Lantabur Apparels Ltd (Extension Unit)

Kewa, Boherarchala Sreepur, Gazipur
(24.1969 N, 90.4071 E)

26 December 2021 & 23 January 2022

Observations

Cylinder test report

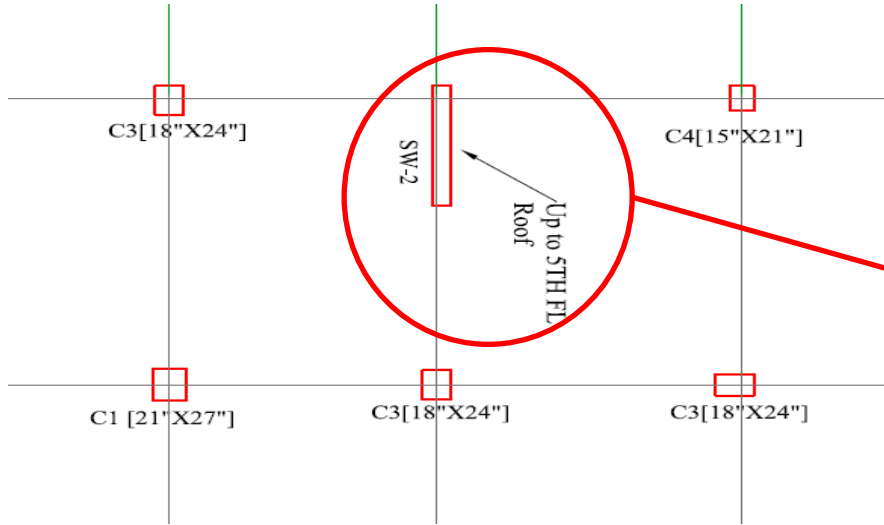
The factory has 12 sets of cylinder test report, among them some doesn't have average value & almost all cylinder tested more than 4 to 10 month later after the sample taking date, which is not conclusive to verify the concrete design strength (24.1 MPa). However, Factory has taken cores from beams & columns to verify in-situ concrete strength, but test report was unavailable during inspection. The building engineer is required to use core test results to verify the in-situ concrete strength as a part of EA.

Figure 2.1.1: 3D View of Analytical Model

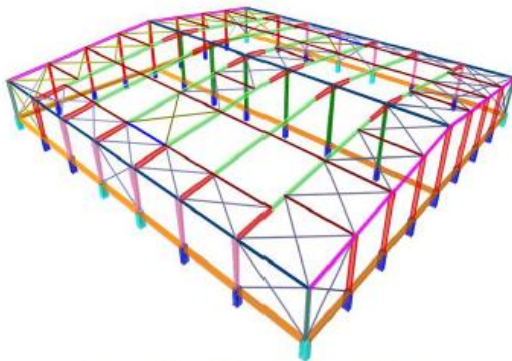
A design report with software-based analysis file was provided for Printing Shed. Purlins (along ridge) are considered as compression member, but adequacy check of the purlins are not provided in the design report.

Concrete compression strength 3500 psi has been considered for short column in design report, but sufficient test report were not available. Also, the test has been performed after 281 days of casting.
